WHEREAS, the City Plan and Zoning Commission has advised that at a public hearing held on September 18, 2008, its members voted 8-0 in support of a motion to recommend **APPROVAL** of a request from Savannah Homes, Inc. represented by Ted Grob (officer), Central Iowa Developers, LC (owners) to amend the Silver Leaf PUD Conceptual Plan for property located at 5100 NE 38<sup>th</sup> Avenue, to allow reconfiguration of the street, alley, and lot layout, including an increase in the number of lots from 131 to 158 subject to the following conditions:

Savannah Homes Inc. (Amend Silver Leaf PUD) - 5100 NE 38th Avenue ZON2008-00130

# PUD CONCEPTUAL PLAN FOR

SILVER LEAF  
AMENDED PUD CONCEPTUAL PLAN  
DES MOINES, IOWA  
SNYDER & ASSOCIATES

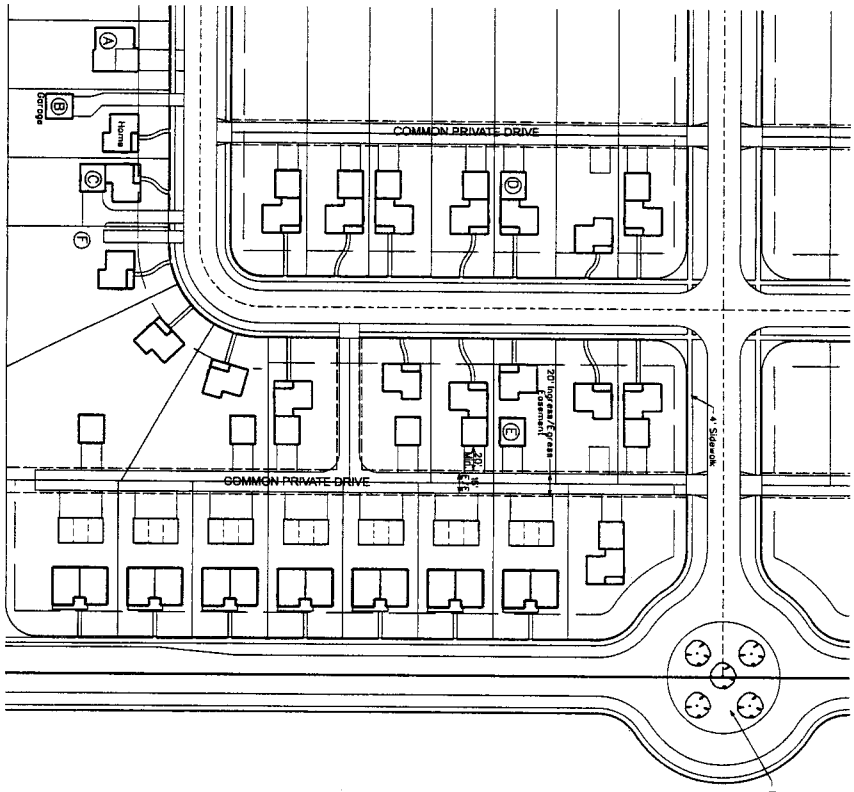
Staff recommends that lots that are less than 60 feet in width at the front yard setback be required to have any attached or detached garage located in the rear yard. The detail provided on Sheet 2 of 3 indicates that the garages on these lots will be accessed by 12-foot wide driveway from the public street to the rear yard. The minimum front-yard setback will be 20 feet (including the porch).
